Access Compliance Report

Public Rights-of-Way

Intersection ID: 52453	Main Street: PAT_GARRETT_ST	Cross Street: DOUBLE_OAKS_RD	Location: NE
ADA ID: DF43AEB24A18	Ramp Type: Directional1	Initial Pass/Fail: Fail	Overall Compliance: No
		Severity Score: 12.5

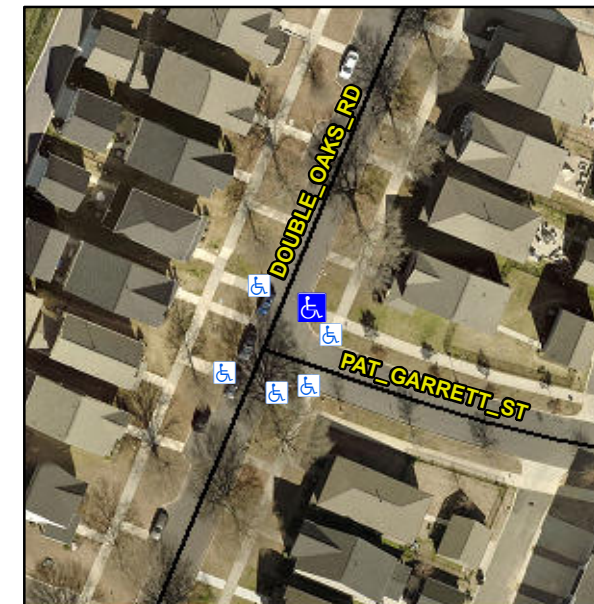
R304.2.2

Compliance	Description	Data	Compliance	Description	Data
N/A	Ramp Length (in)	83.0	N/A	Grade Break?	N/A
Yes	Ramp Width (in)	60.0	N/A	Grade Break Slope (%)	0.0
No	Ramp Slope (%)	9.7	N/A	Grade Break XSlope (%)	0.0
Yes	Ramp XSlope (%)	1.2			
N/A	Flare Type LT	N/A	N/A	Flare Type RT	N/A
N/A	Flare Slope LT (%)	N/A	N/A	Flare Slope RT (%)	0.0
N/A	Flare Traversable LT?	N/A	N/A	Flare Traversable RT?	N/A
N/A	Landing Length (in)	0.0	N/A	DWS Provided?	N/A
N/A	Landing Width (in)	0.0	N/A	DWS Contrast?	N/A
N/A	Landing Slope (%)	0.0	N/A	DWS Length (in)	N/A
N/A	Landing X Slope (%)	0.0	N/A	DWS Full Width?	N/A
N/A	Landing Curb? (Y/N)	N/A	N/A	DWS Offset LT (in)	N/A
N/A	Shared Landing?	N/A	N/A	DWS Offset RT (in)	N/A
N/A	Gutter Ponding?	0.0	N/A	Gutter Slope (%)	N/A
N/A	Gutter Lip Ht (in)	2.0	N/A	Gutter X Slope (%)	N/A
N/A	Painted X Walk1?	No		Road Slope (%)	2.9
	X Walk 1 Direction	To W		Road X Slope (%)	0.2
	X Walk 1 Width (in)	N/A		Clear Space?	N/A

Remove & Replace Entire Ramp.
